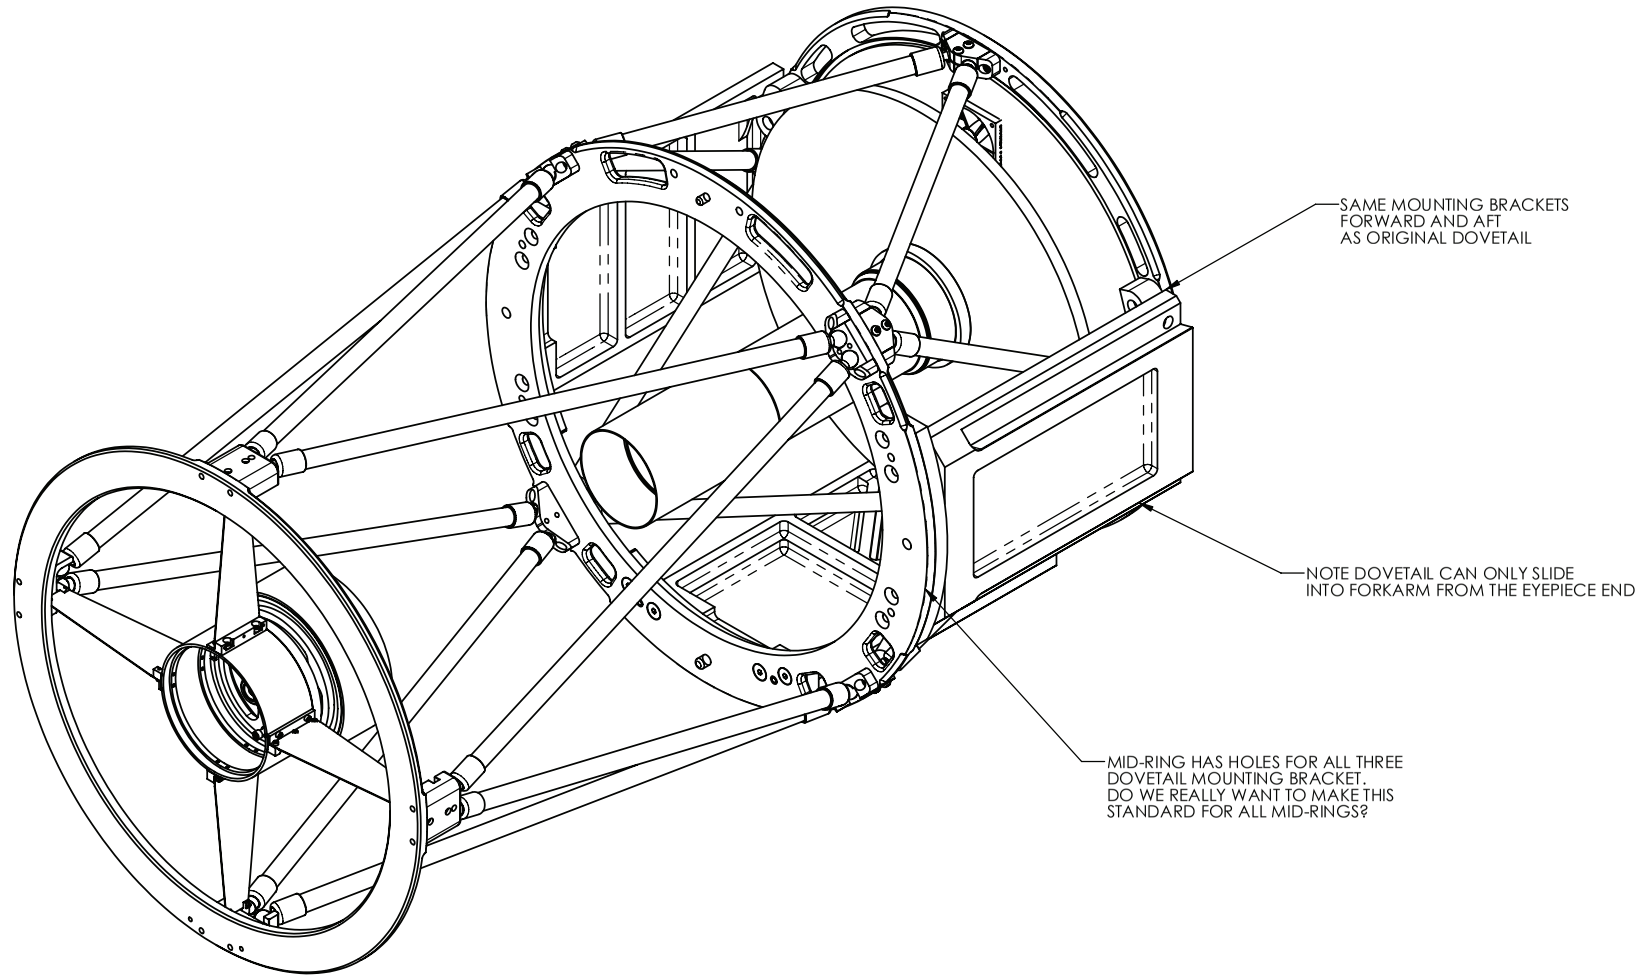
SAME MOUNTING BRACKETS
FORWARD AND AFT
AS ORIGINAL DOVETAIL
NOTE DOVETAIL CAN ONLY SLIDE
INTO FORKARM FROM THE EYEPIECE END
MID-RING HAS HOLES FOR ALL THREE
DOVETAIL MOUNTING BRACKET.
DO WE REALLY WANT TO MAKE THIS
STANDARD FOR ALL MID-RINGS?

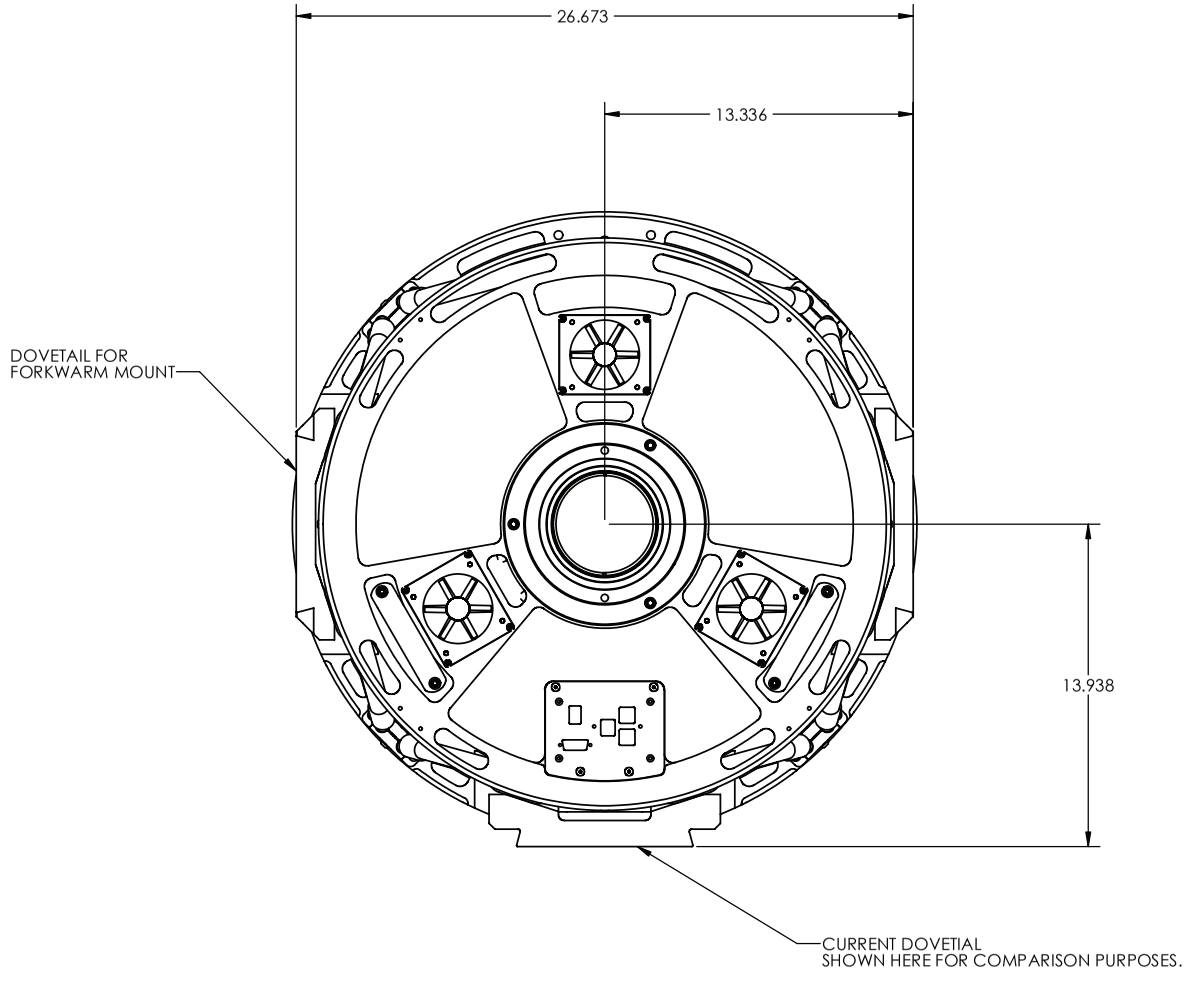
26.673
13.336
13.938
DOVETAIL FOR
FORKWARM MOUNT
CURRENT DOVETIAL
SHOWN HERE FOR COMPARISON PURPOSES.

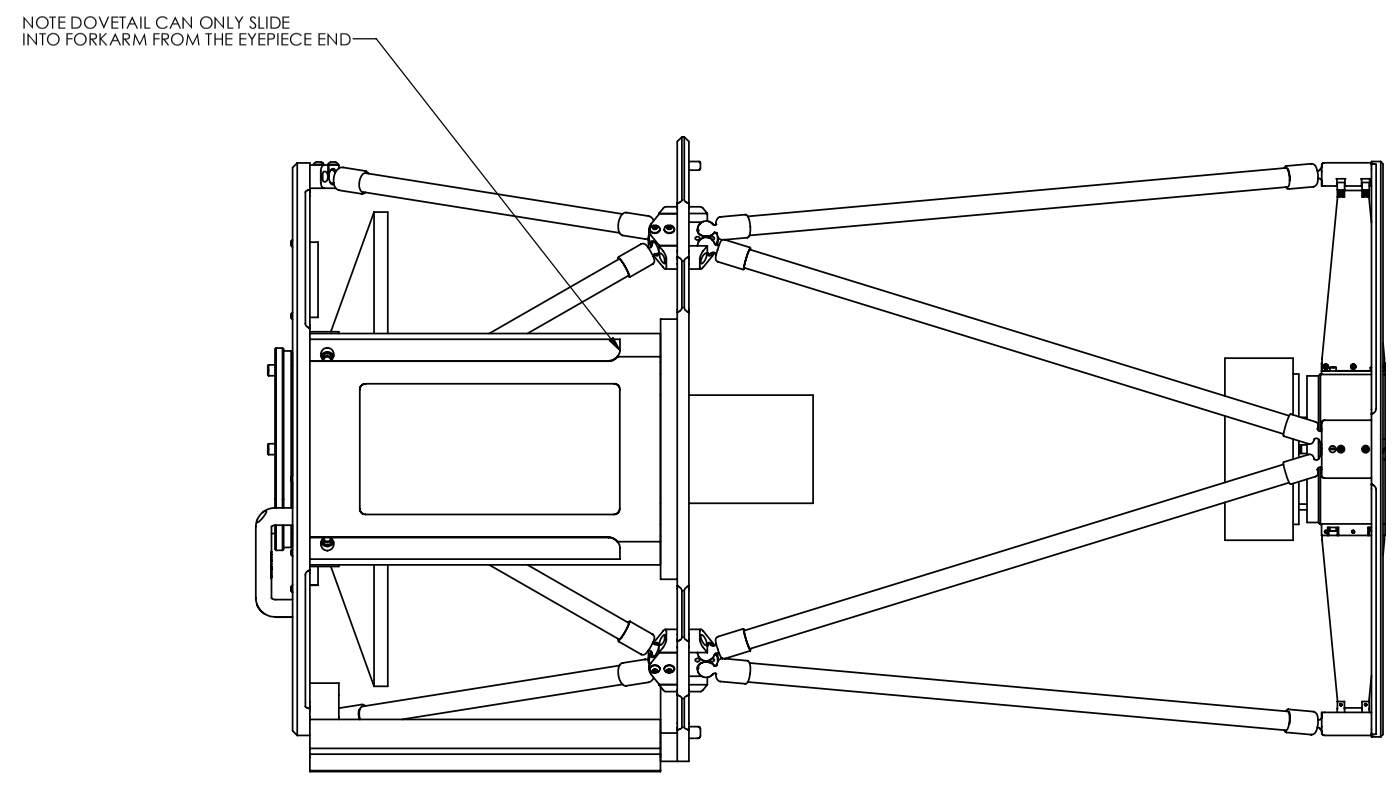
NOTE DOVETAIL CAN ONLY SLIDE
INTO FORKARM FROM THE EYEPIECE END
